SUBJECT: Requests relief from certain requirements of ASME Section XI associated w/partial exams conducted during 1995 plant refueling outage ISI.

**VIRGINIA ELECTRIC AND POWER COMPANY**  
**SURRY POWER STATION UNIT 2**  
**INSERVICE INSPECTION PROGRAM RELIEF REQUESTS**

**Attachment 1**  
**Surry Power Station Unit 2**  
**ISI Examination Relief**

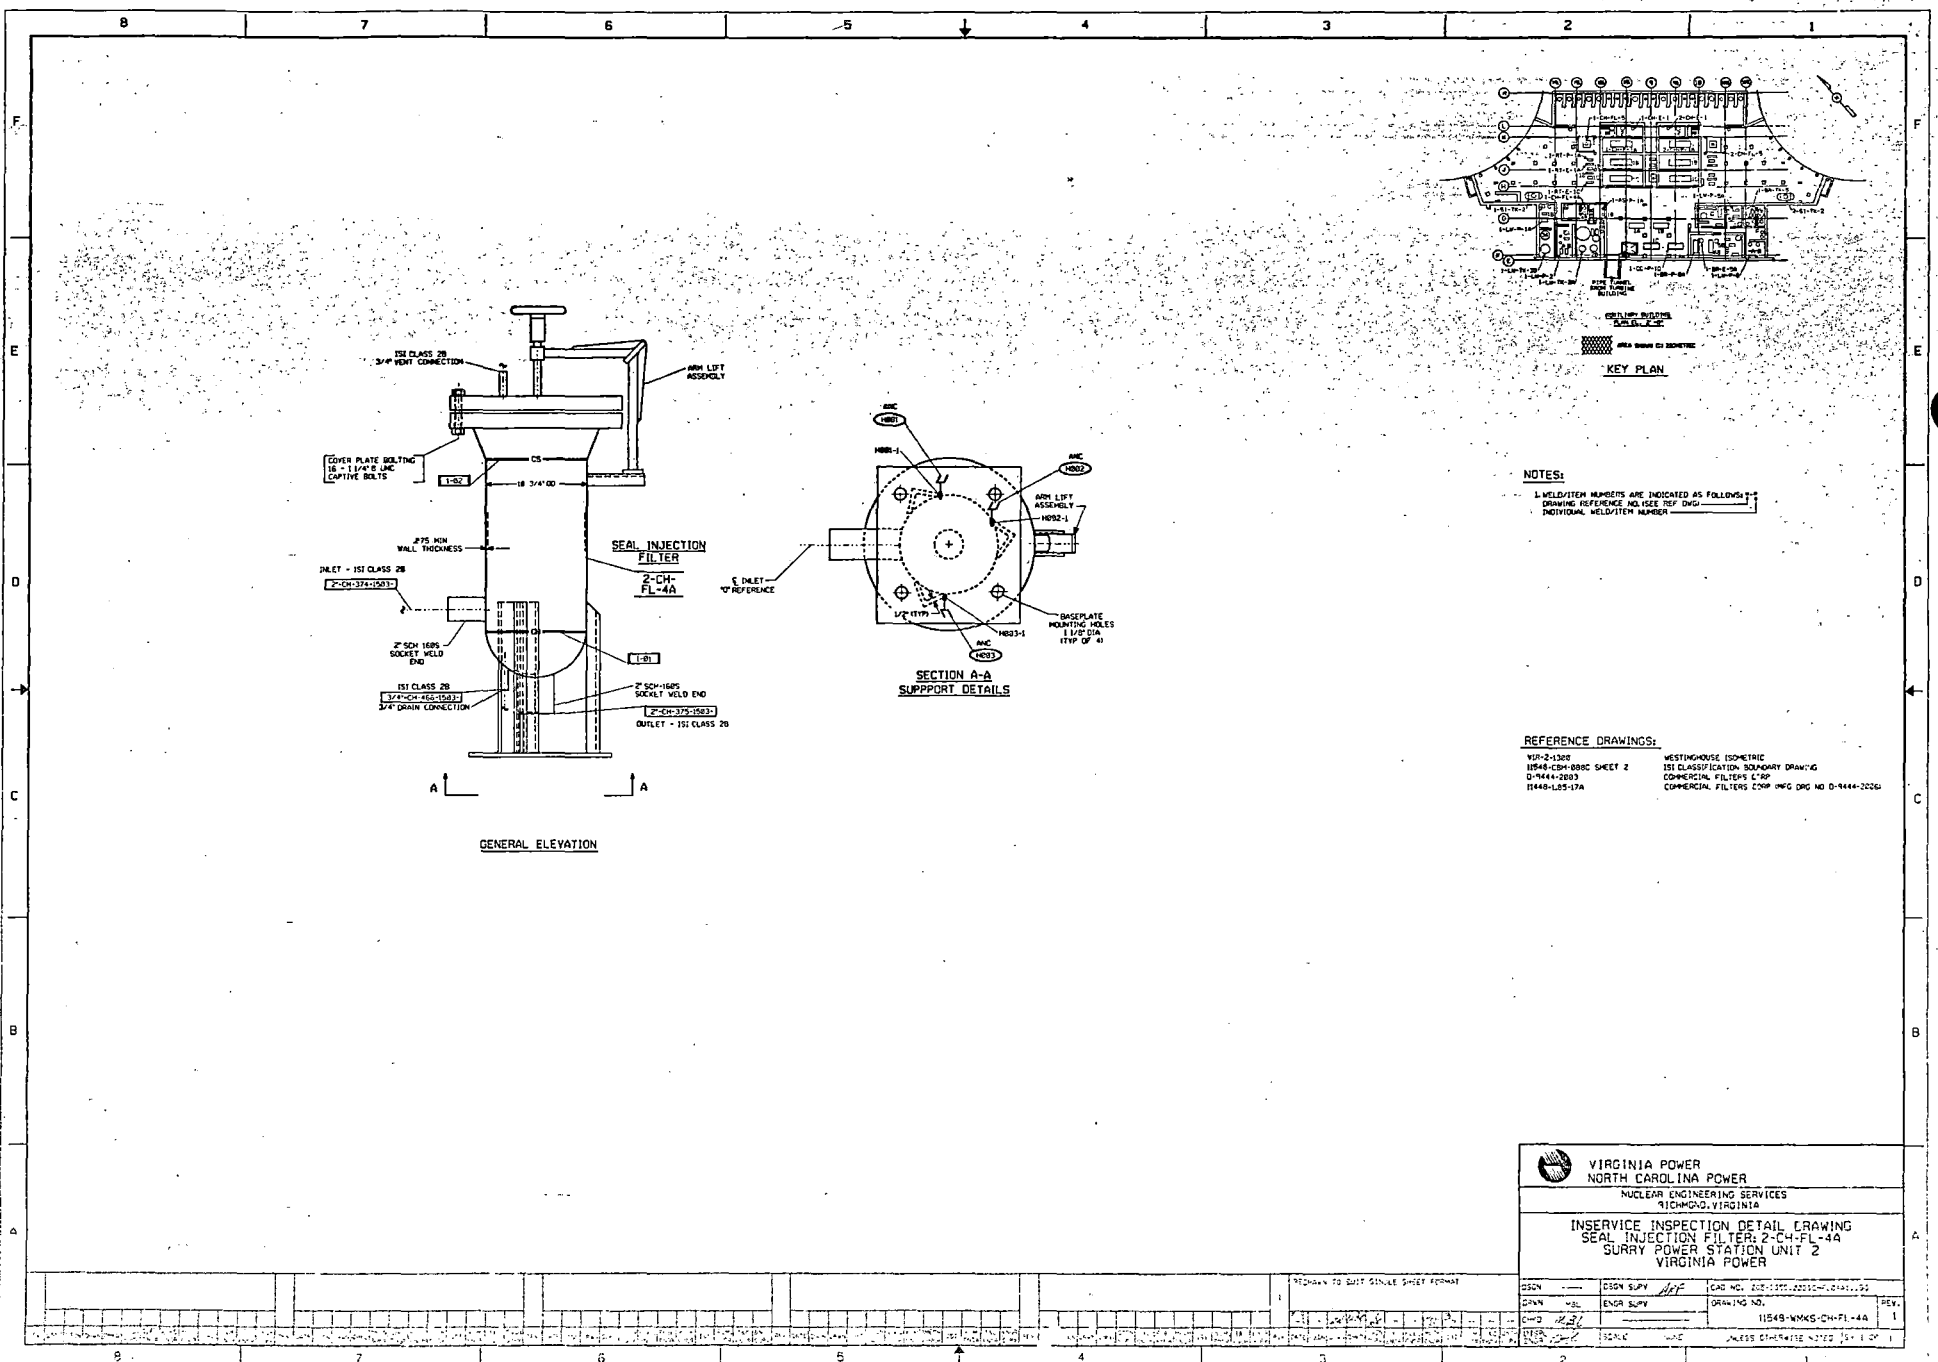
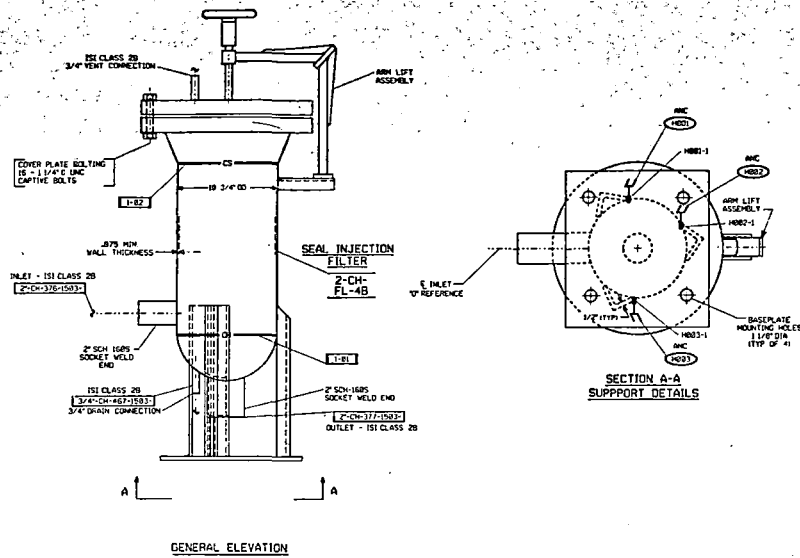
<u>Mark/Weld#</u>	<u>Drawing#</u>	<u>Class</u>
1-01	11548-WMKS-CH-FL-4A/B	2

31"-RC-308-2501 R WELD 1-09  
FIGURE SR-25-1

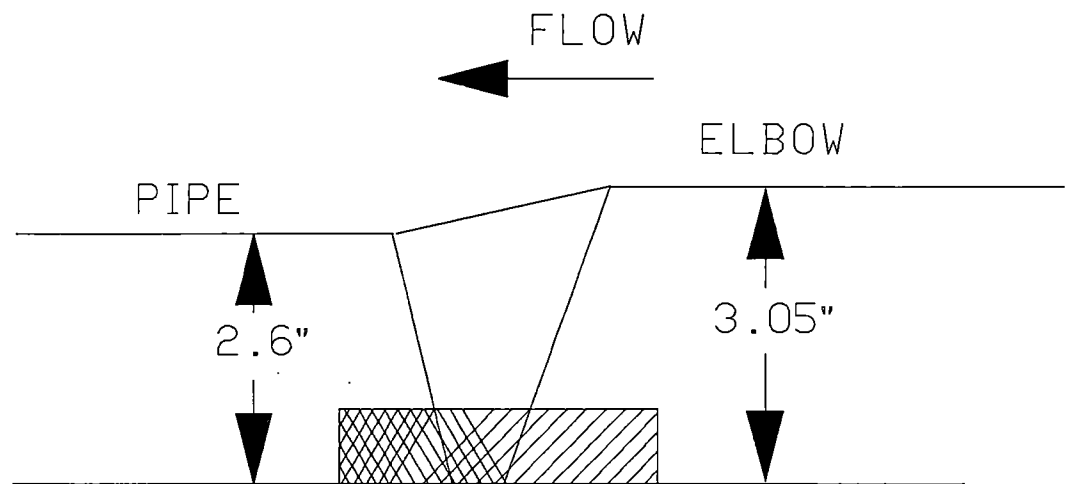
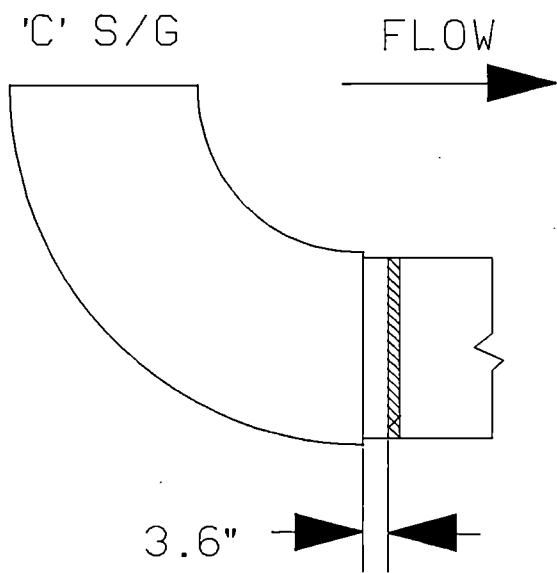
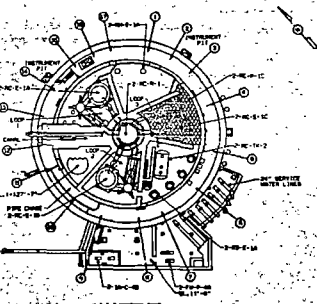
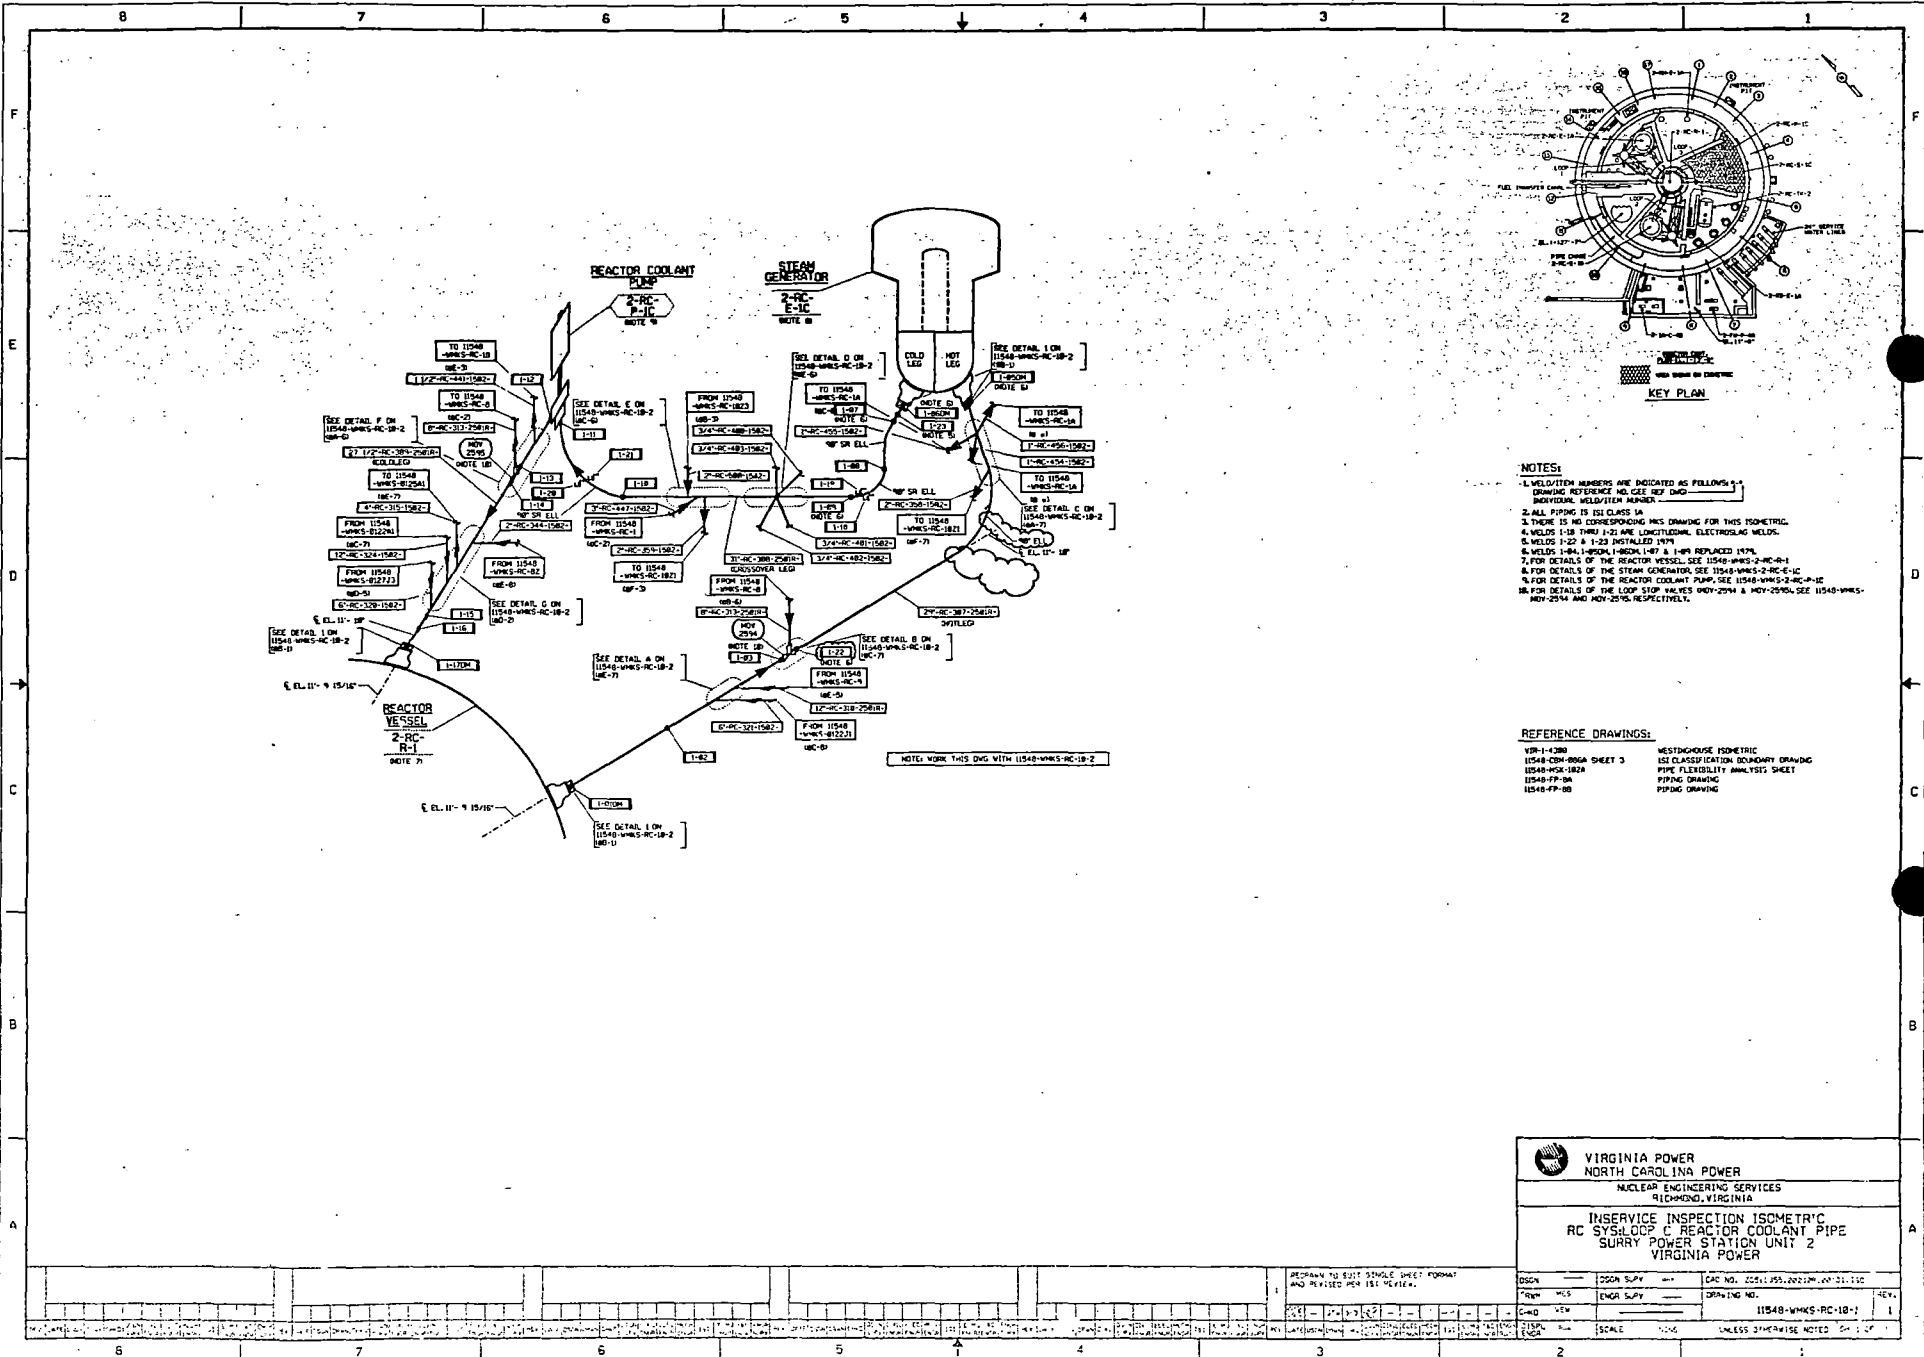
The component listed above has been examined to the extent practical as required by the Code. Due to the geometry of the weld crown the reduction in coverage of the volumetric examinations are detailed in Table SR-25-1. Figure SR-25-1 is provided detailing the limitations experienced. Substituting with another weld of the same size would not necessarily improve the examination coverage since similar geometric conditions are expected.

<u>Mark/Weld#</u>	<u>UT Scan Coverage %</u>				<u>Surface Examination Coverage %</u>	<u>Reason For Partial</u>
	<u>2</u>	<u>5</u>	<u>7</u>	<u>8</u>		
1-09	50	83	72	72	100	The geometry of the weld crown limits the coverage in the area of pipe to weld and weld to elbow. Material type, ASTM A-351 austentic steel casting, limits the use of an extended V-path examination.

It is proposed that the examination already completed at the reduced coverage be counted as meeting the Code requirements.

Figure SR-26-1

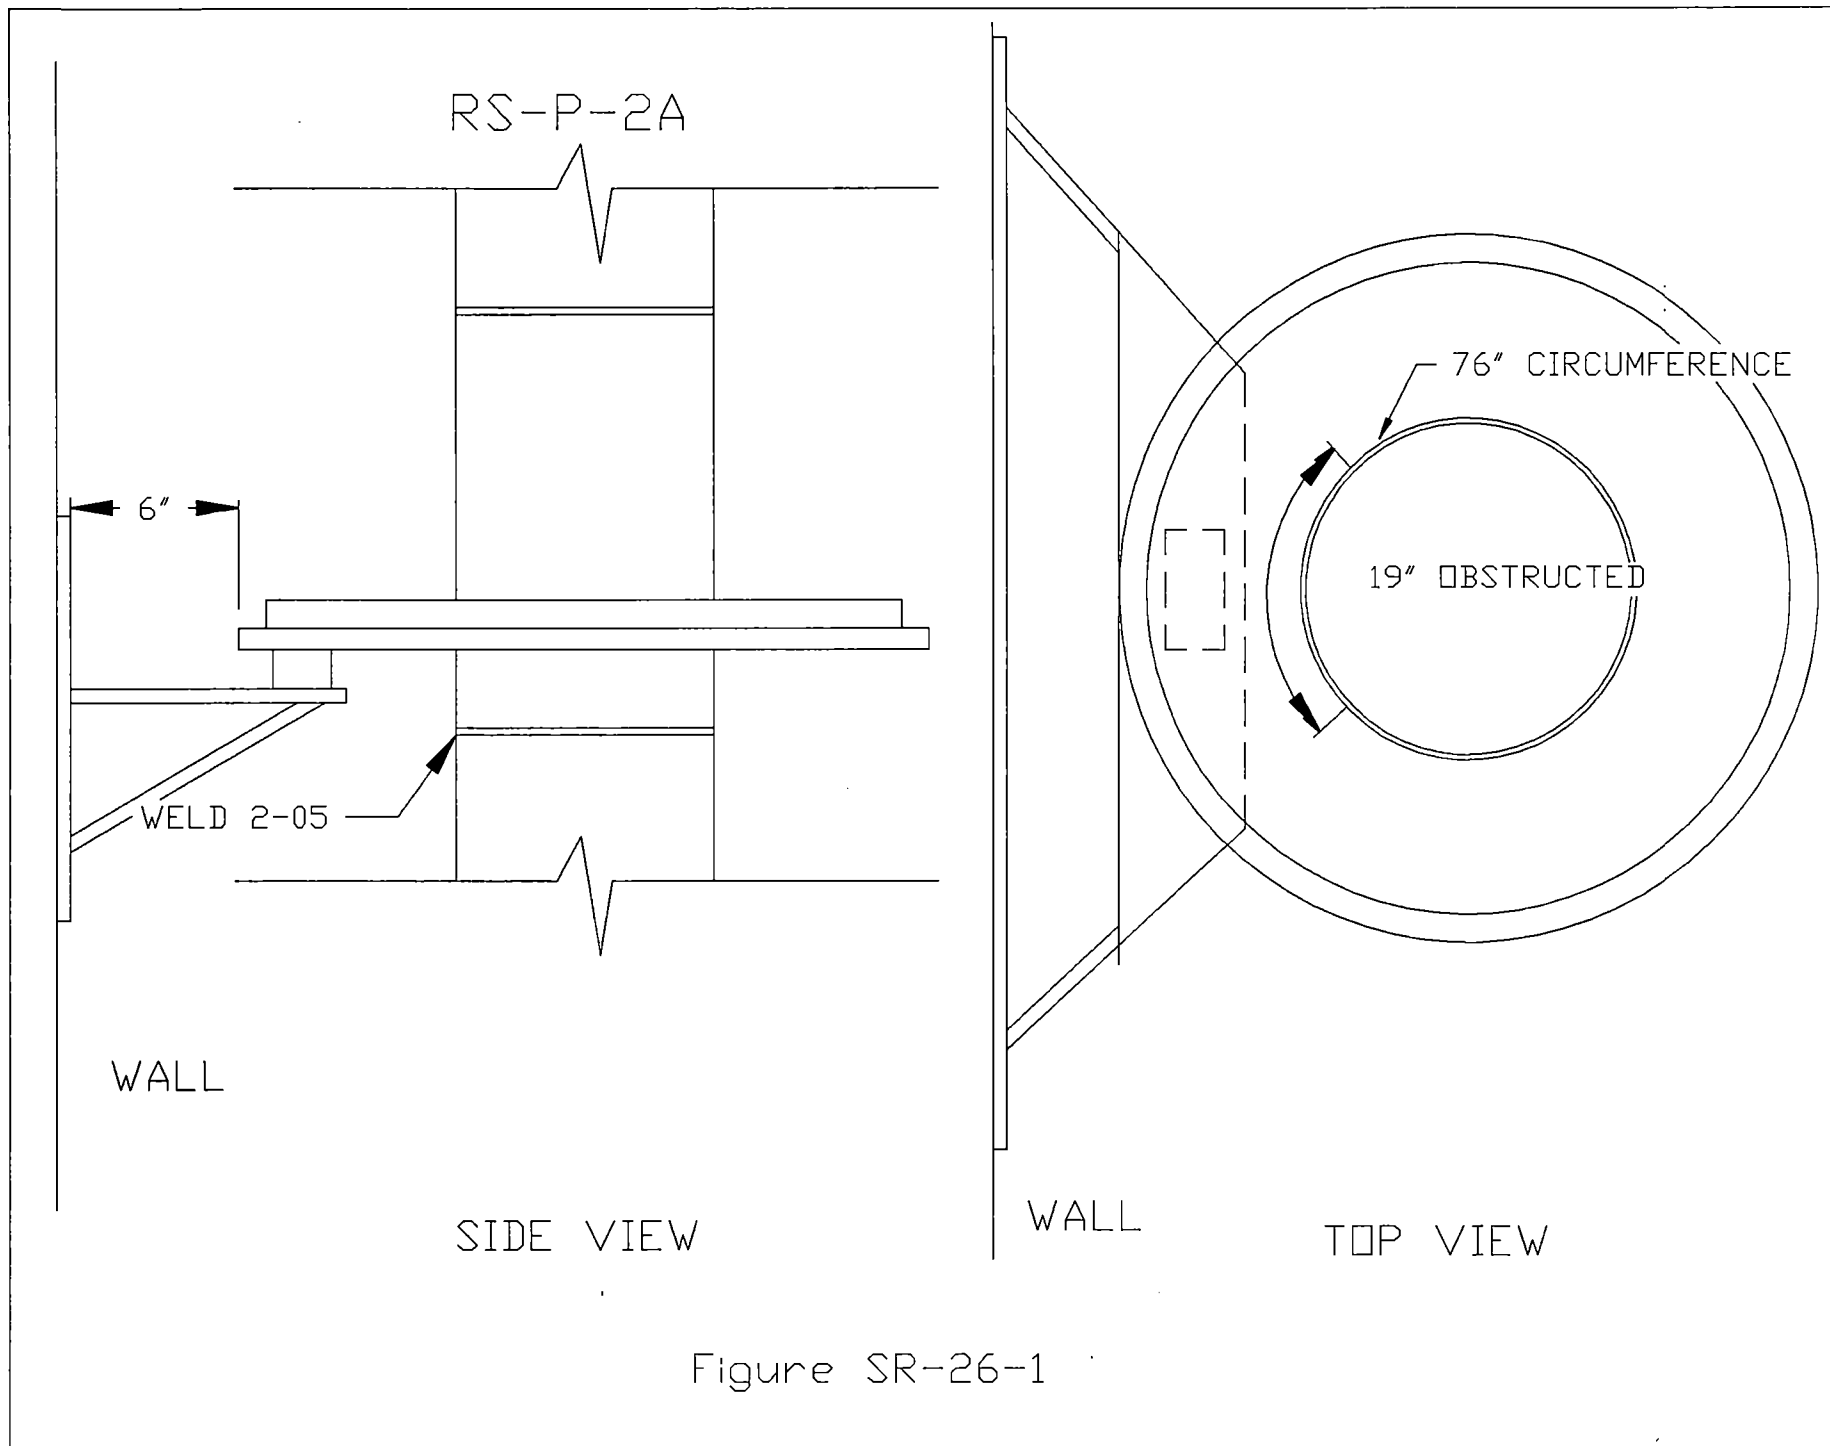
The component listed above has been examined to the extent practical as required by the Code. Due to interferences from a pump casing support the reduction in coverage of the surface examination was 25%. Figure SR-26-1 is provided detailing the limitations experienced. No other alternative is available for substitution since the "B" pump has the same limitation.

It is proposed that the examination already completed at the reduced coverage be counted as meeting the Code requirements.
